APPEAL # 7

2020-1853-ZC

ZONING STAFF REPORT

AMENDMENT PLAN -COTTON CREEK A PLANNED UNIT DEVELOPMENT

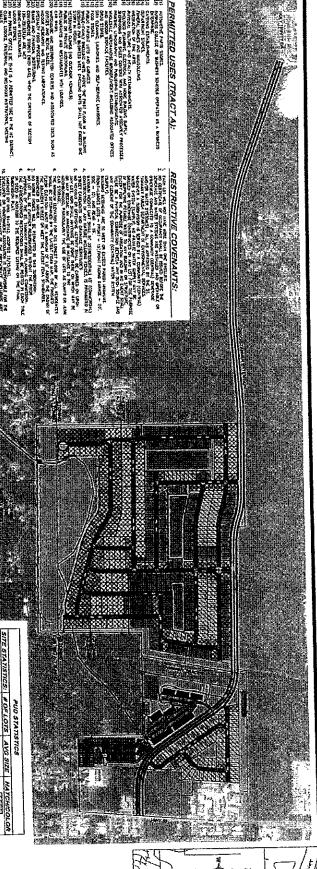
Notwithstanding the forgoing, staff has concerns as it relates to the layout of the greenspace and amenities that are proposed. The PUD plan shows the majority of the greenspace located in the southern portion of the development. The only access points to this greenspace are from two proposed cul-de-sacs and there is no parking provided. A significant purpose of the Planned Unit Development Overlay is to provide functional and beneficial uses of open space. Staff recommends providing park spaces with active amenities within the development to ensure all residents have access to close by recreational space.

Additionally, if the applicant would like to maintain the majority of the greenspace along the southern perimeter of the proposed development, staff recommends providing a formal access point. Staff also recommends an amenity within the greenspace itself. Currently, the Upper Bayou Chinchuba runs along the northern perimeter of this greenspace, causing limited access for enjoyment. A passive amenity such as a nature trail or board walk will allow access and provide a recreational feature that preserves the natural characteristics of the development site. Per Sec. 130-1674(8)(c), active and passive uses shall be designated within the required greenspace (see Table 4).

- 1. Environmentally sensitive design that is of a higher quality than would be possible under the regulations otherwise applicable to the property.
 - The current PUD plan shows development encroaching the existing Upper Bayou Chinchuba flood way along the southern portions of the site.

- 3. Functional and beneficial uses of open space areas.
 - A large majority of the greenspace that is provided is shown along the southern portion of the PUD plan. There are two adjoining streets that allow pedestrian access to the greenspace. Staff recommends the applicant accommodate a formal access to the greenspace along the southern portion of the plan and provide more usable greenspace or park space within the plan.

- The current PUD plan shows development encroaching the existing Upper Bayou Chinchuba flood way along the southern portions of the site.
- 5. Creation of a safe and desirable living environment for residential areas characterized by a unified building and site development program.
